75% PLAN REVIEW

NOVEMBER 16TH, 2020

Shake Shack – Oak Lawn, IL
4071 W. 95TH St.
Oak Lawn, IL 60453

Henderson Engineers
8345 Lenexa Drive, Suite 300
Lenexa, KS 66214

M001: mechanical notes:

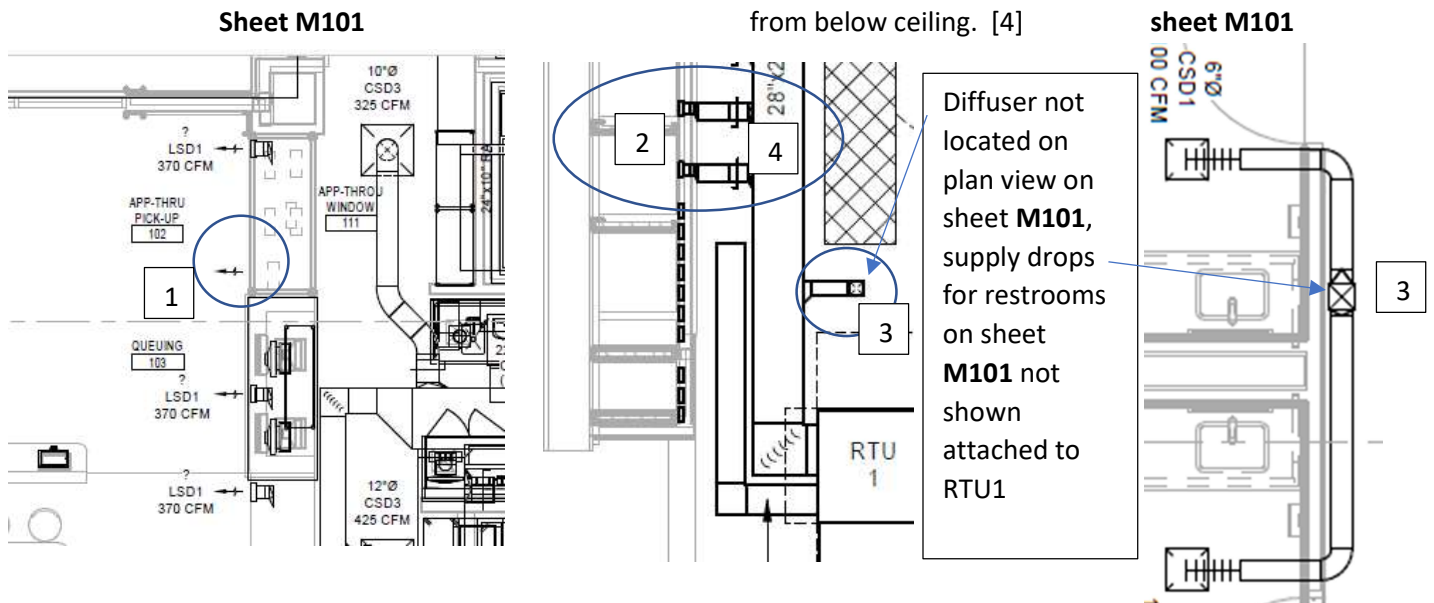
To be consistent insert “locking quadrant” in Note 21.

21. PROVIDE A **[LOCKING QUADRANT]** MANUAL BALANCING DAMPER IN EACH DUCT TAKEOFF FROM SUPPLY, RETURN, OUTDOOR AND EXHAUST AIR DUCTS.

M101 & M150: dining RTU details

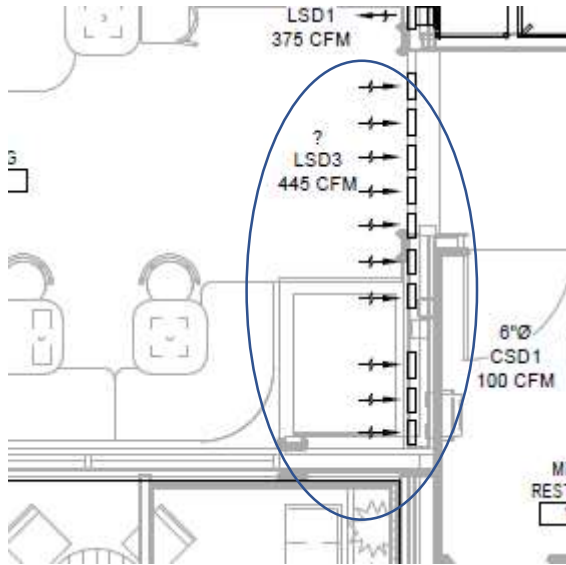
- [1] M101: Dining RTU-1, incomplete diffuser plan (75%). Ensure dampers are accessible (outside of any hard lid)
- [2] Linear supply diffusers nearest the returns, consider throw pattern on diffusers to ensure supply air does not short directly back to return.
- [3] restroom diffusers and restroom corridor diffuser do not show connected to RTU1.

Sheet M150- damper at main – ensure access from below ceiling. [4]

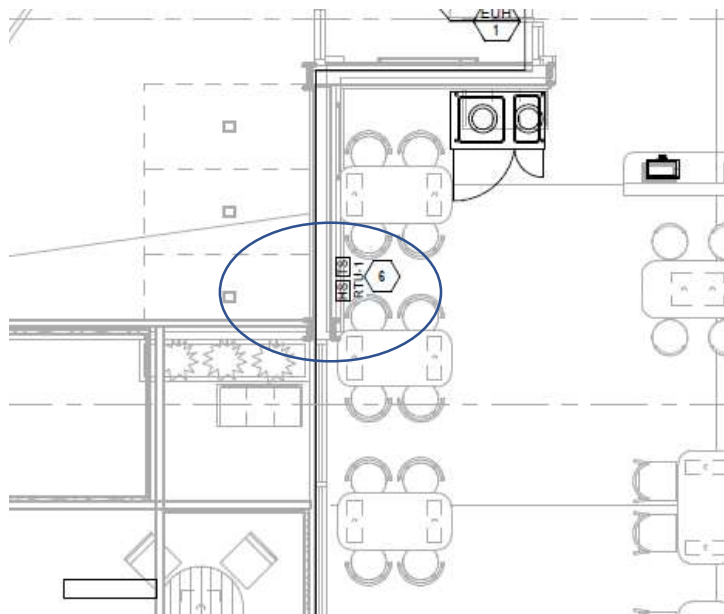
- Dining linear return slots not complete or shown with registers connected to branch/main return ducts, ensure diffuser branch ducts have accessible dampers (outside of any hard lid encase they are set shut or fail shut).

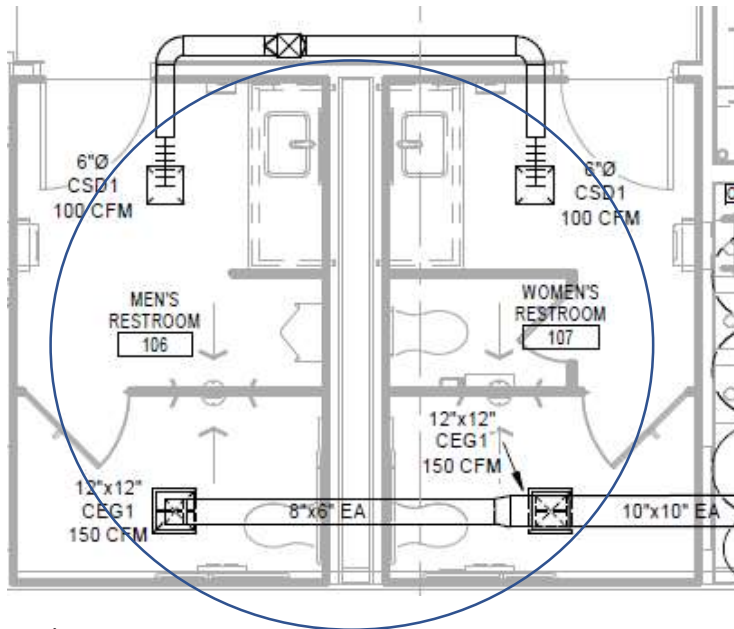
RTU-1 Suggest moving temp / humidity sensor to interior wall if possible or detail proper insulation from wall cavity and surface. Protect sensors from incidental contact since they are located between two customer tables.

Kitchen RTU:

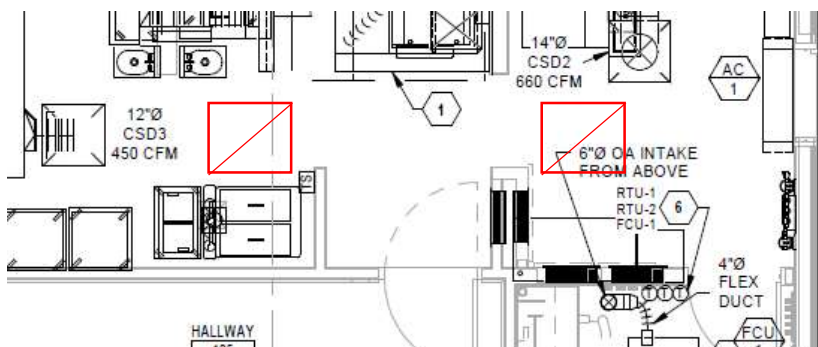
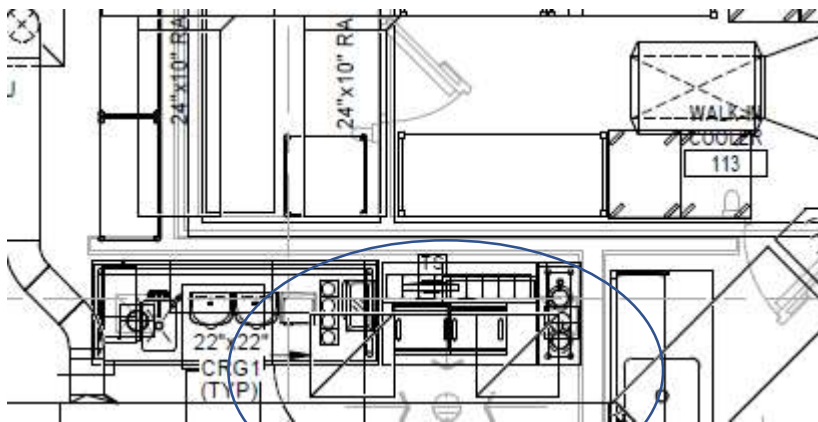
Appears to be open – plenum return. Only two open return openings are in back the of the kitchen near the walk-in cooler. We highly suggest open (or ducted) returns are distributed to both ends of the kitchen. If open return, prefer a small return plenum box be installed on top of any open return with damper to allow for distribution of return air path to prevent drafts across the hoods. Returns also need to be 10ft from exhaust hoods

Office fan coil.

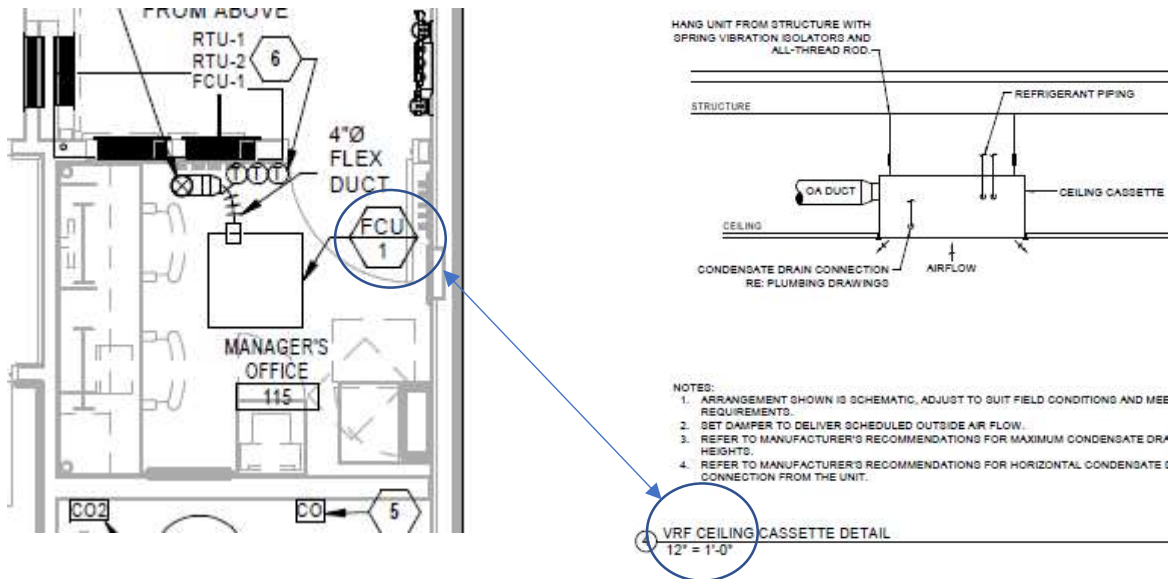
Relabel FCU-1 to VRF ceiling cassette on sheet M101 to match detail from sheet M501

Fan coil accessibility details should be illustrated on plans, specific to blower, electrical, and filter compartments. Shall follow applicable code guidelines for accessibility.

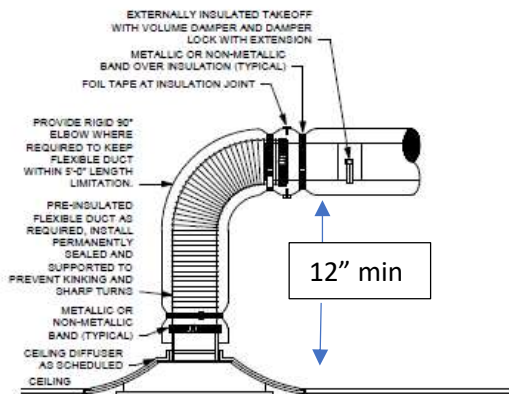
Consider showing 4" line damper in OA duct for fan coil

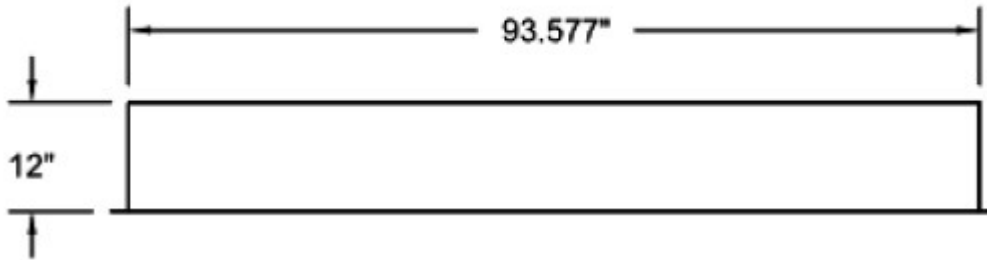
M601 relabel table to VRF ceiling cassette to match sheet M101 and ceiling cassette detail M501

3 ITEM # 1-1, 1-2 SECTION VIEW

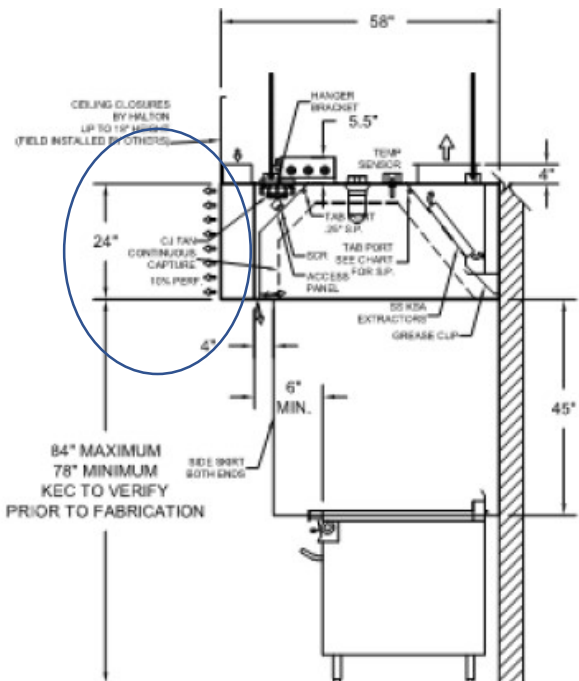
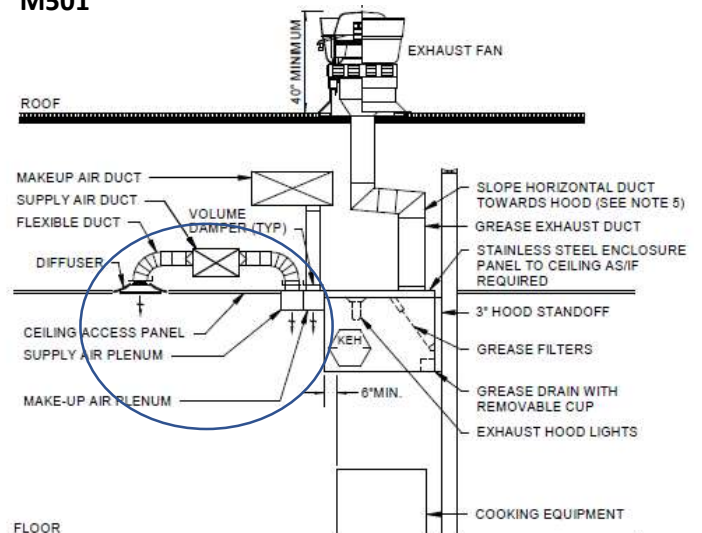
M702 Halton hood section detail differs from sheet M501 section detail. Planned supply plenum detail on M501 should match manufacturers supply orientation on M702.

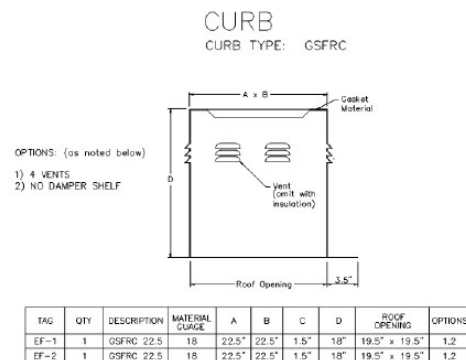
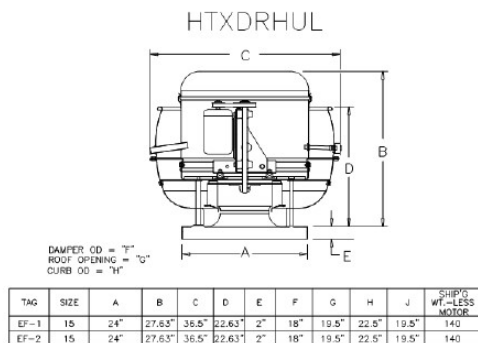
M704: Code requires discharge point of exhaust fan to be minimum of 40" above finished roof. Curb dimension "D" is 18" tall. Fan Dimension "D" is 22.63" tall. The total height is 40.63". This does not allow for securing curb directly to deck and being sunk below possible roof batting. Suggest a 20" tall curb to ensure 40" clearance can be maintained.

Curb hinging details and fan fastening details should be shown.

P120 (ITEM 100 IS END OF LINE)

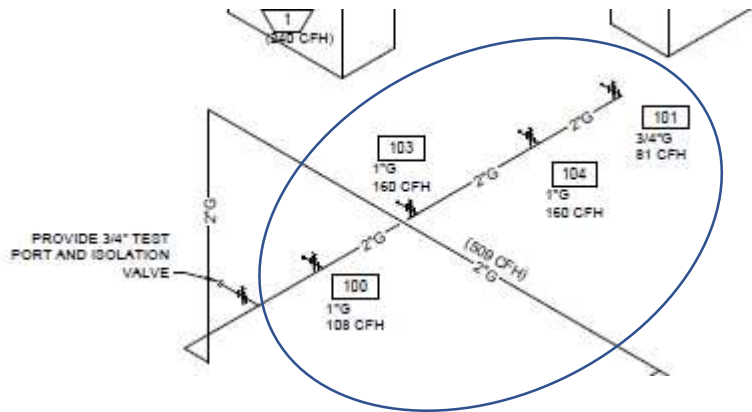
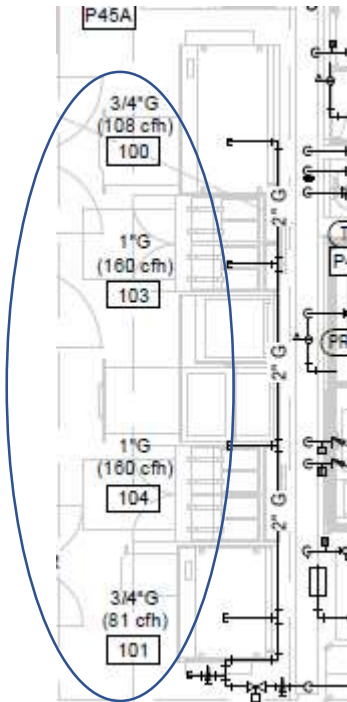
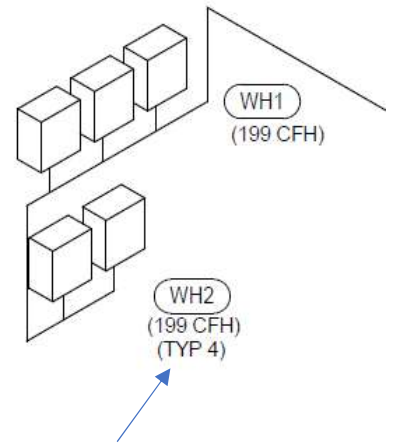
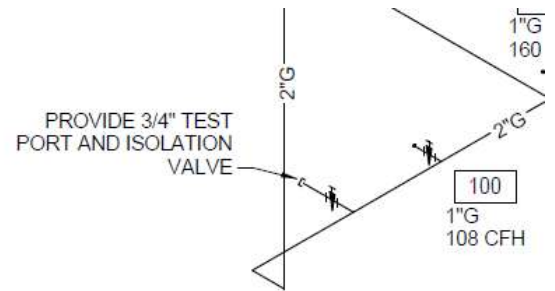
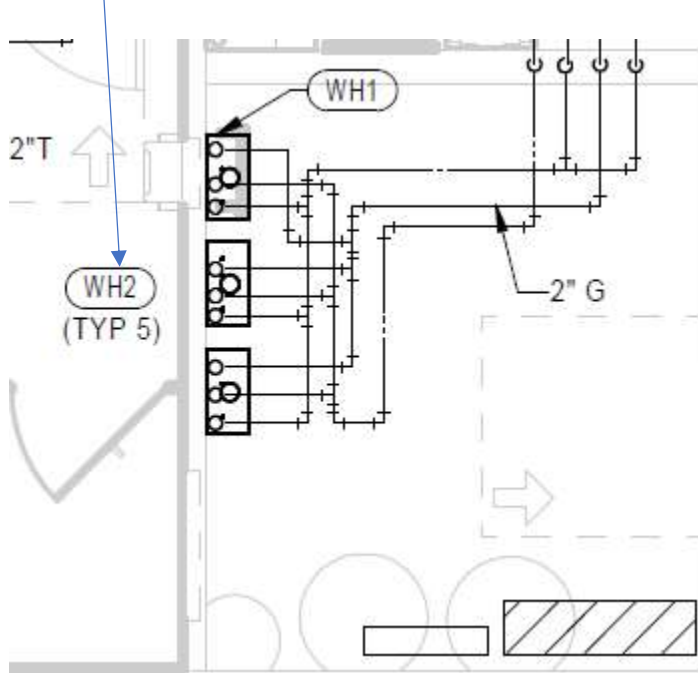
P120 and P901: Cook line gas connections per item are shown in reverse order from each other when comparing sheet P120 and sheet P901. Need to validate connection order to sequence properly on each sheet

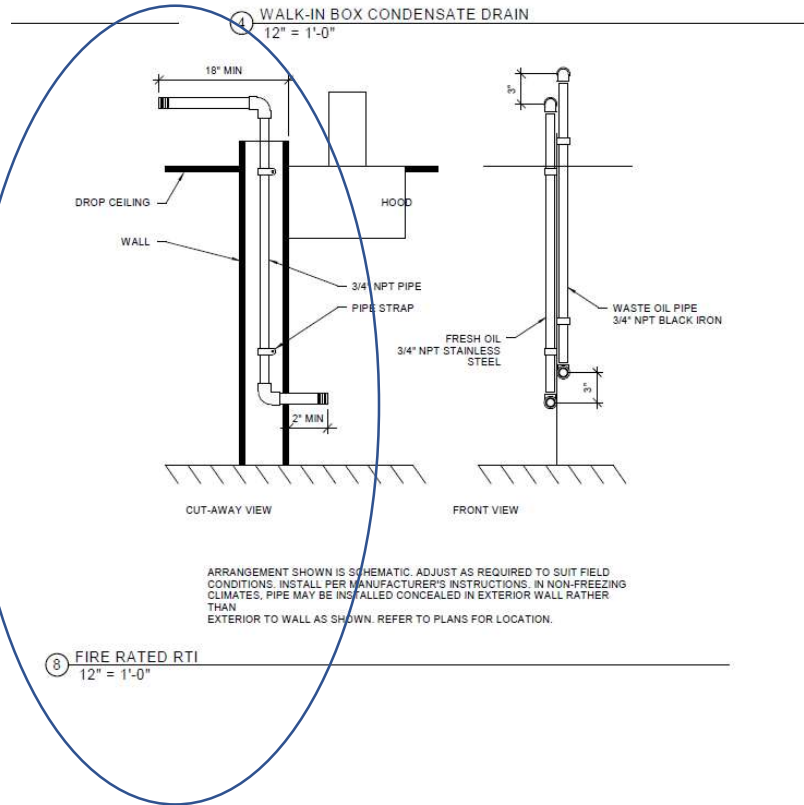
Water heater – **P120**: water heaters shown – note indicates WH2 (TYP 5)

Detail **P901** (left) shows Two water heaters WH2 shows TYP 4 which differs from comment on P120 (above)

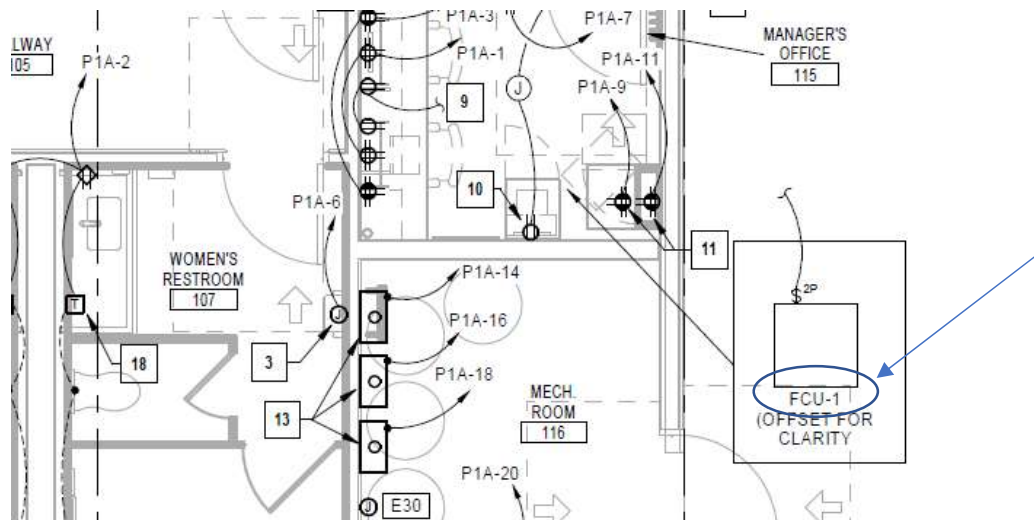
E101 – note 5 references note 7, seems to imply that it should reference note 6

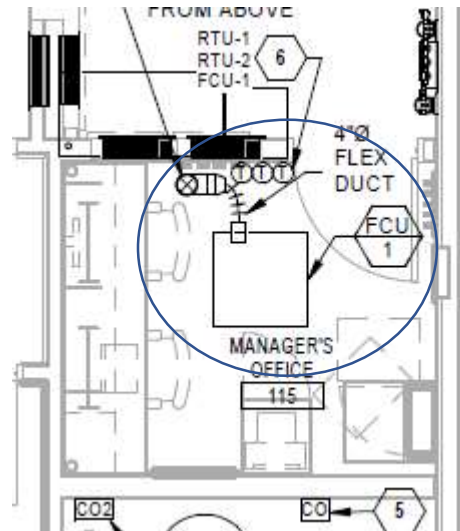
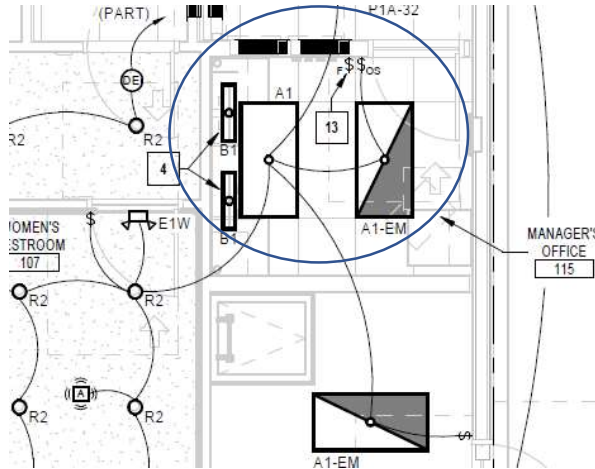
E101 - For consistency rename managers office FCU-1 to VRF (same as mechanical plan detail)

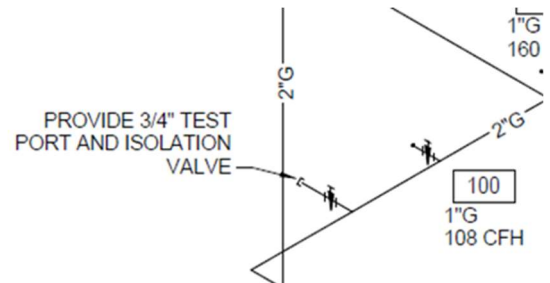
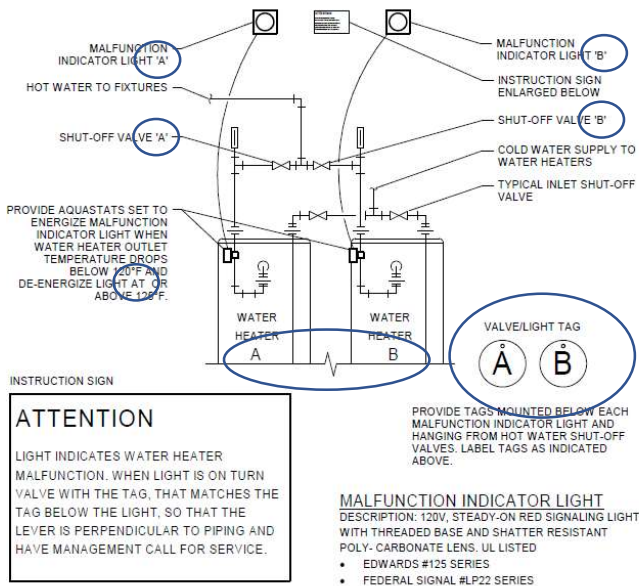
E120 – Manager’s office emergency Light and VRF cassette Cartridge (sheet M-101) should be coordinated by contractors or shown to ensure they do not infringe on each other’s required location.
